USCAN 3.5 UPGRADE

Notable Changes to the Uscan Software

Possible Reasons for Poor Results

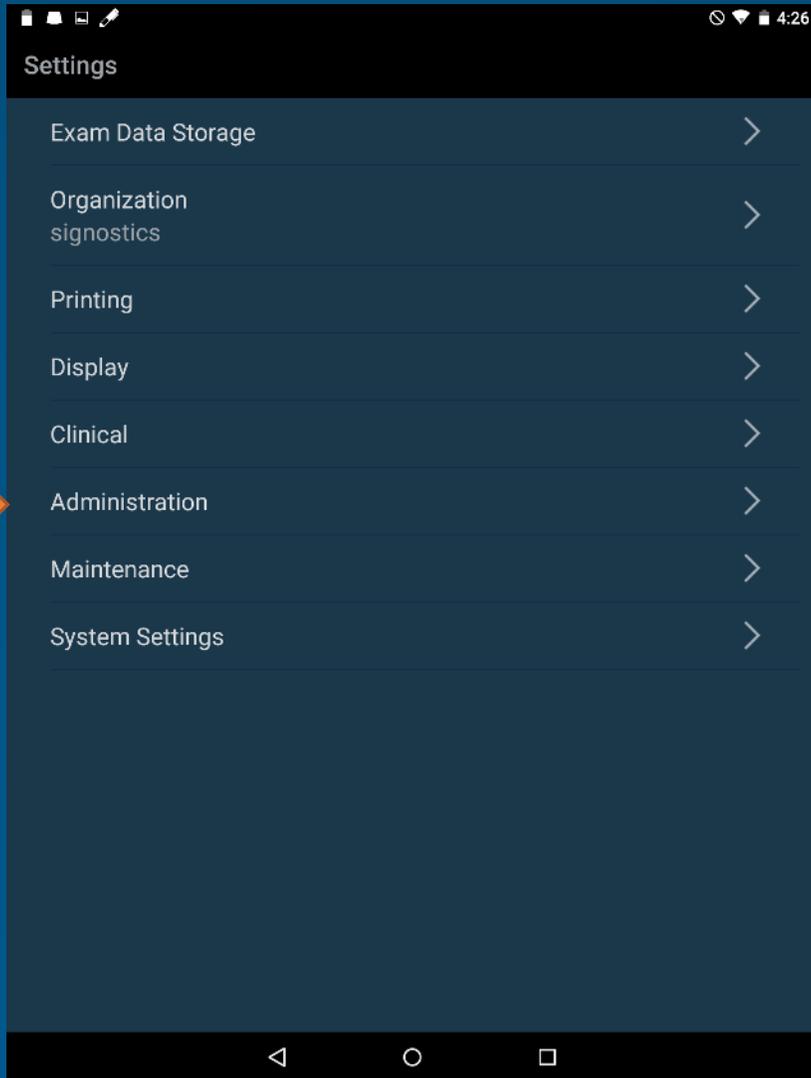
Changes to “0” ml Result

This statement replaces the “0” ml reading

User must tap the question mark or the statement to obtain possible reasons for the result.

- Instead of the "0 ml" result, 3 reasons for the not obtaining the bladder volume are presented

- 1). The bladder is nearly empty
- 2). The Uscan encountered too much scar tissue
- 3). Or the user technique was poor and a repeat is necessary

Note: *The training videos are available from this screen*

Administration

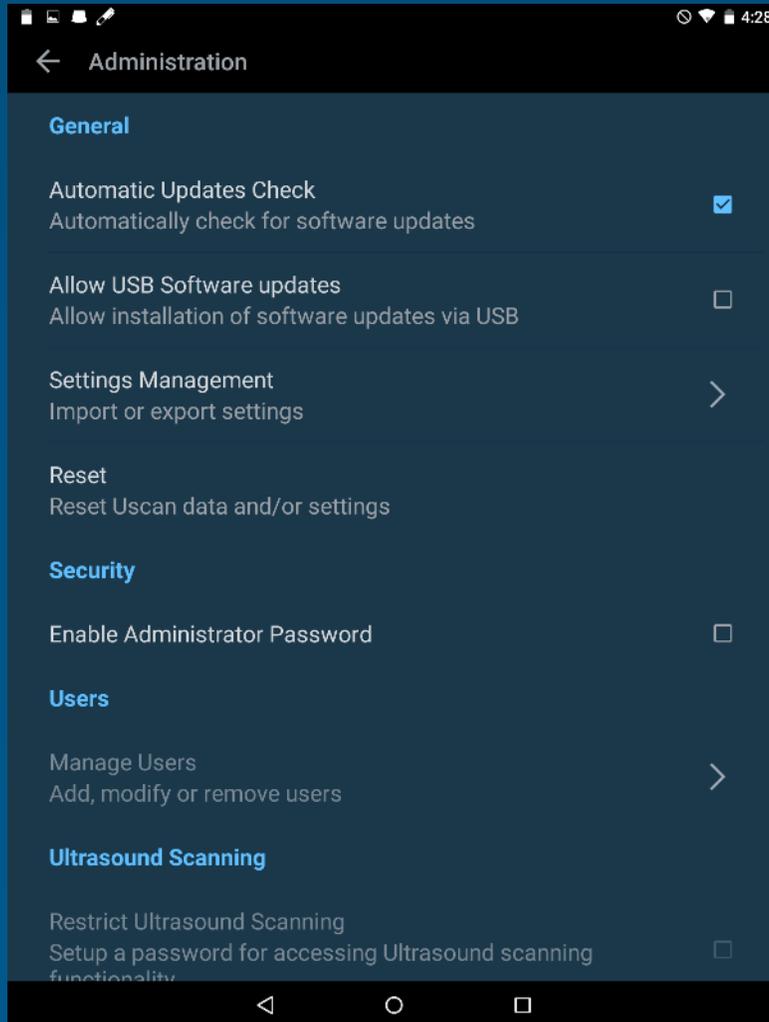
A password will be necessary to change features associated under the “Administration” tab

This password must be remembered or the tablet will have to be reset by Signostics

Administration

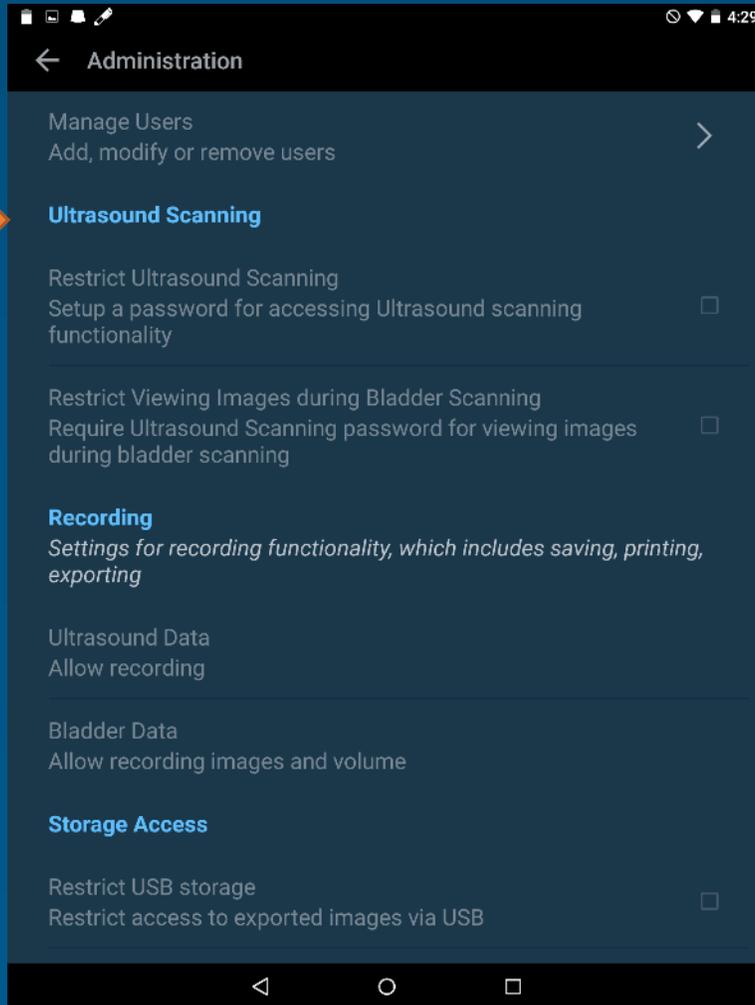
- **Automatic Updates Check** – Same as before
The Uscan now allows the USB port to be used for upgrades via thumb/flash drive. This use requires permission from the admin
- **Settings Management** permits setting from one Uscan to be easily transferred to another (same as before)
- **Reset** allows the Admin to default the tablet
- **Users** there is no change other than the location

Administration

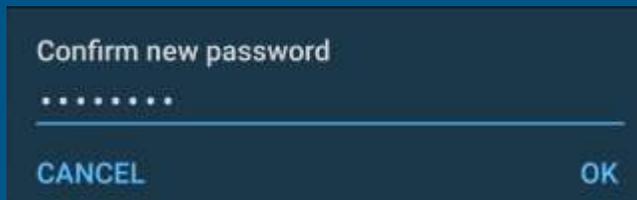
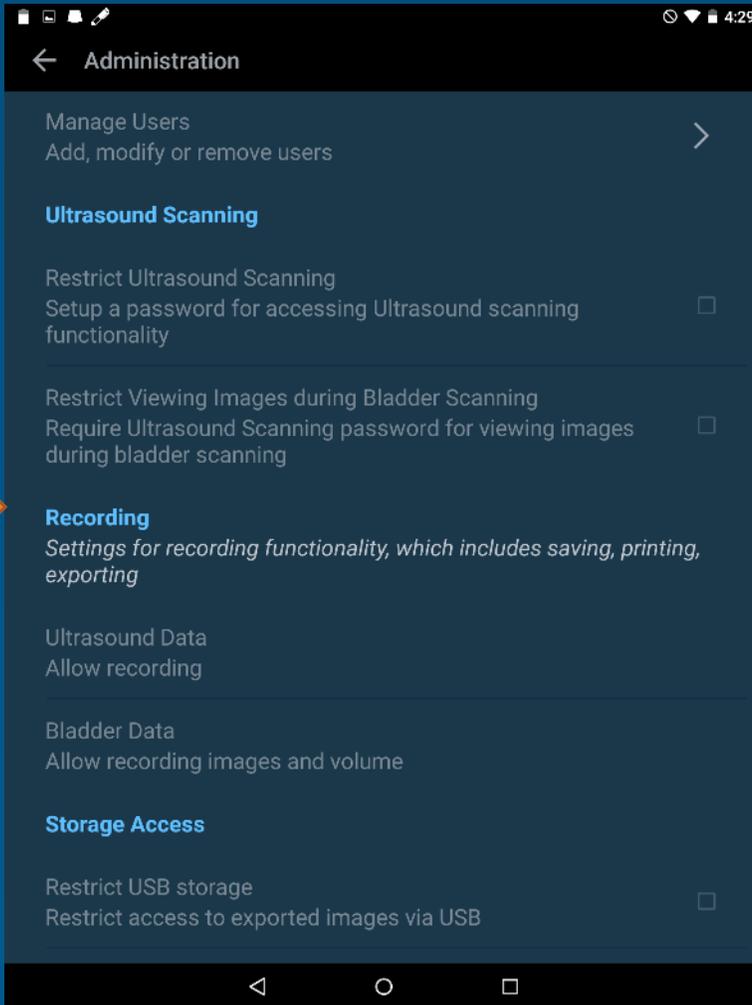
Ultrasound Scanning can now be locked down. Scanning is restricted to password use only if desired. Also, viewing images during bladder scanning (makes bladder scanning very difficult) can be turned off for those very rare instances when a customer is concerned that an unqualified user is looking at anatomy

NOTE: *An admin password is absolutely required for this feature to be applied*

Administration

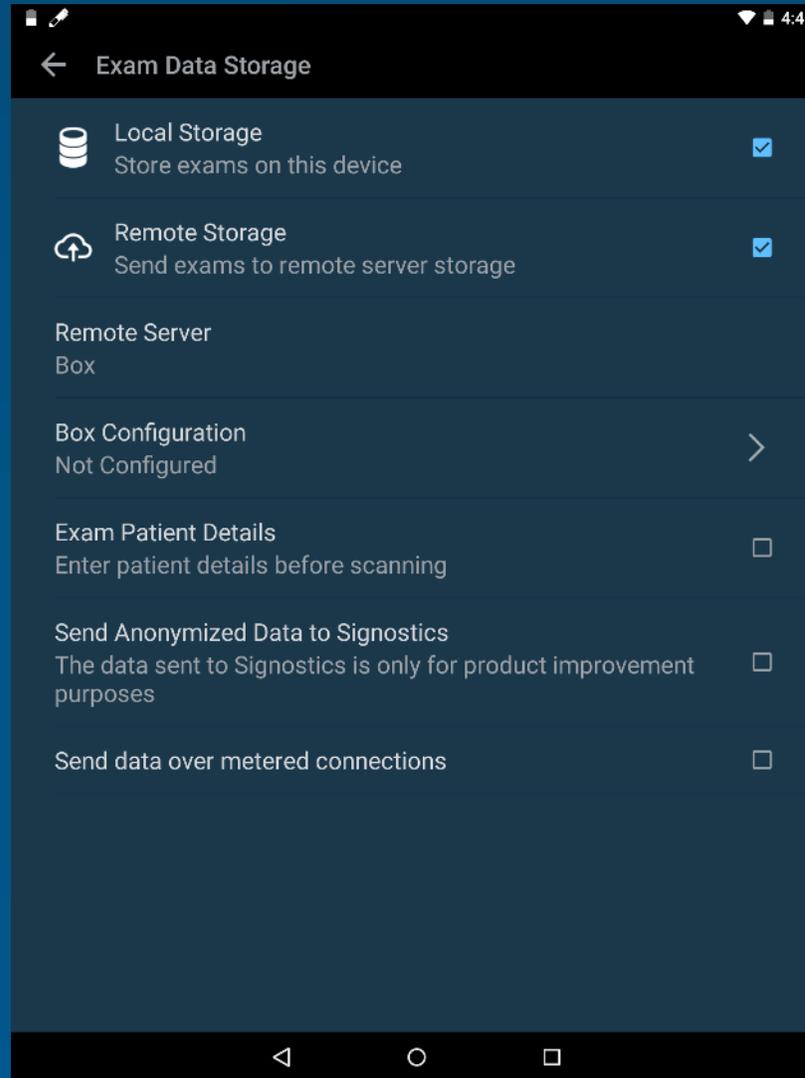
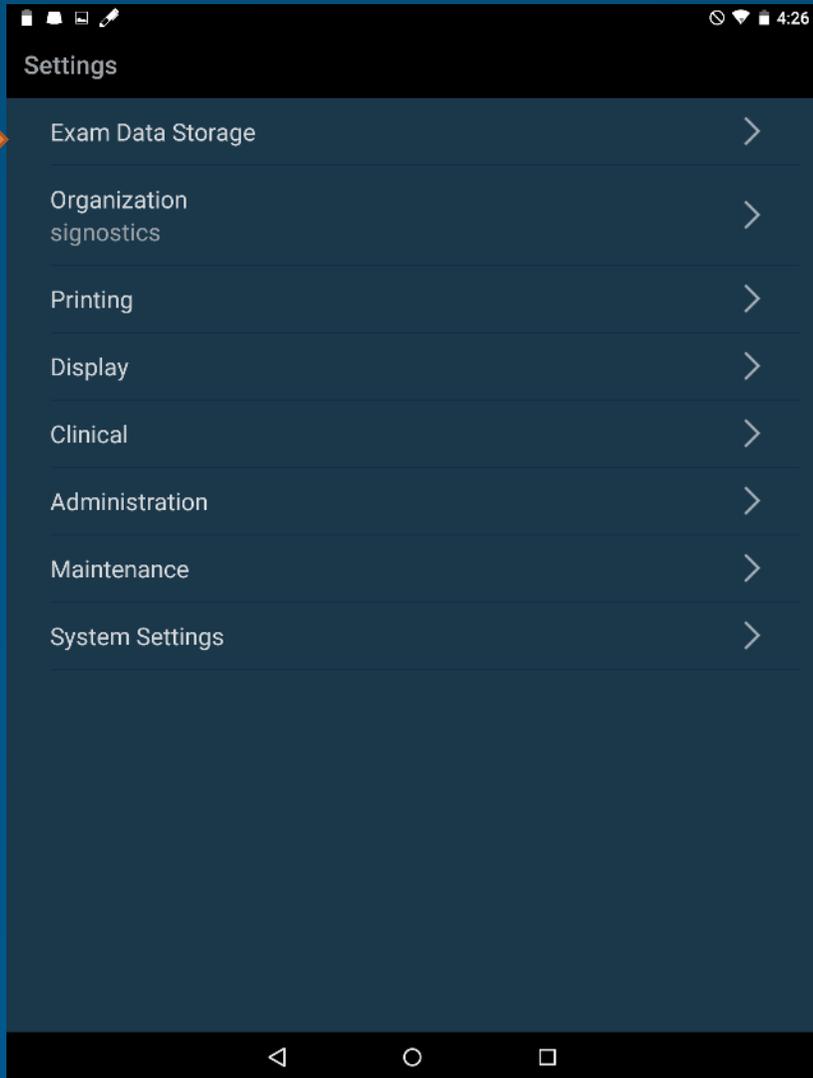
Storage Access feature allows the USB port to be shutdown. Images cannot be stored or viewed by linking the tablet to a computer via USB cable.

NOTE: An admin password is absolutely required for this feature to be applied

Printing

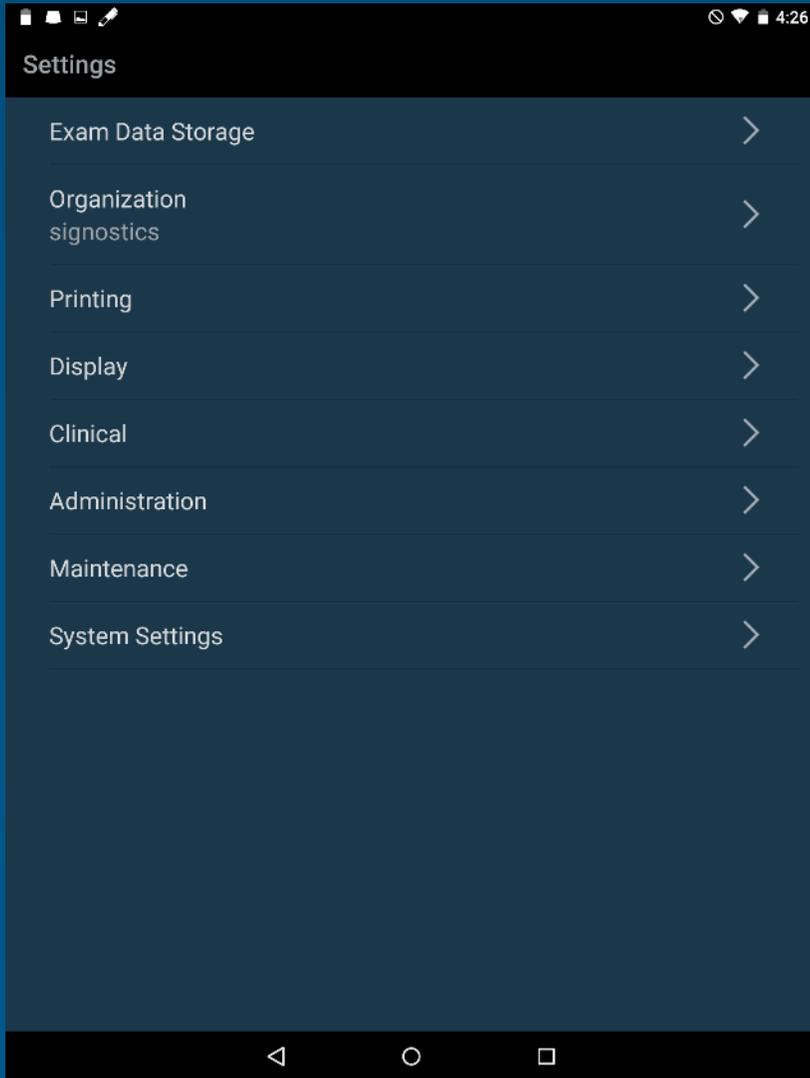
Choose Printer Type

Network printing is configured through the Mopria tab in the System Settings tab

Bluetooth printing only works with the Bluetooth printer sold by Signostics

Note: Not all network printers will work
